Type Coffee Vending Machine	Model 9XXX - 95	N° T.I. 01 - 2021					
Serial Number See below	Subject NEW ESPRESSO VALVE ASSEMBLY	ISSUED FOR (X)	<table border="1"> <tr> <td>Action</td> <td></td> </tr> <tr> <td>Information</td> <td>X</td> </tr> </table>	Action		Information	X
Action							
Information	X

Be informed that with the aim to improve our equipment, the *Espresso valve assembly* has been modified. This modification will ensure a better crema layer / taste and will avoid a vibrating (noisy) espresso valve and less pollution in the cup area.

In between assembly from production - machines from S/N 03120637 to S/N 11720576

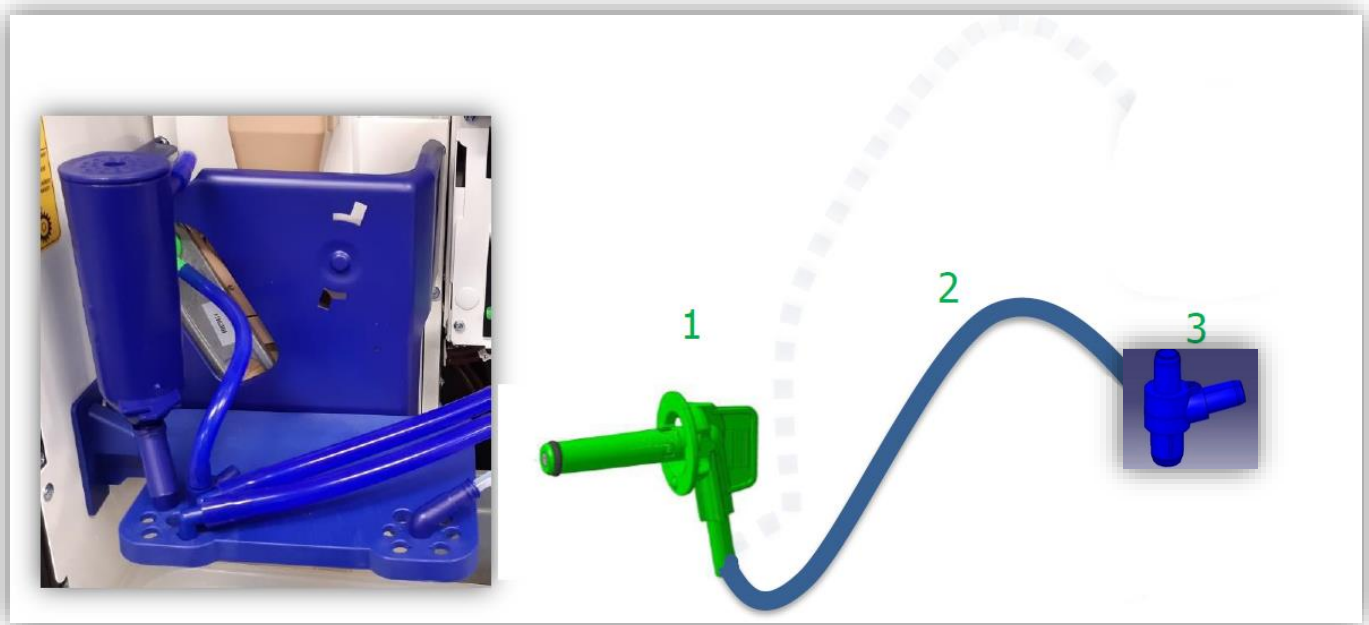
979284 Kit Retrofit ES Valve – Nozzle / SAP: 55120328 will be phased out

New final assembly from production → machines concerned from S/N 11720576

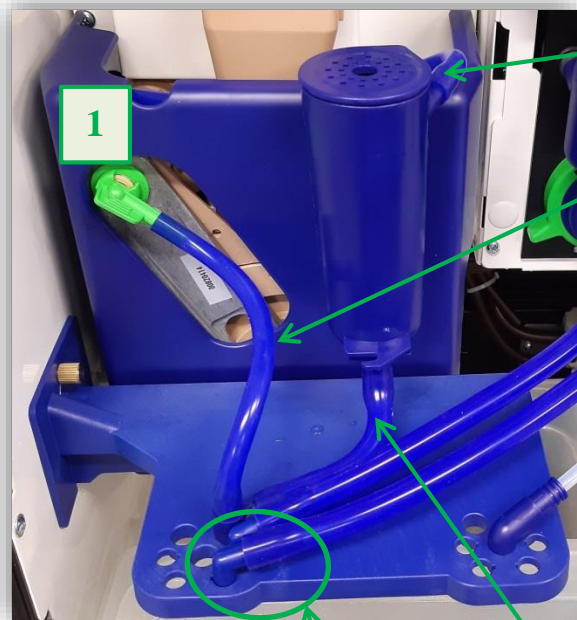
5 Blue silicone hose for Fresh brew (5x9)
Length: 240 mm

Blue silicone hose for Espresso (5x9)
Length: 160 mm **2**

3 New ESFB nozzle

4 blue silicone hose (6,7x12 - Length: 100 mm)
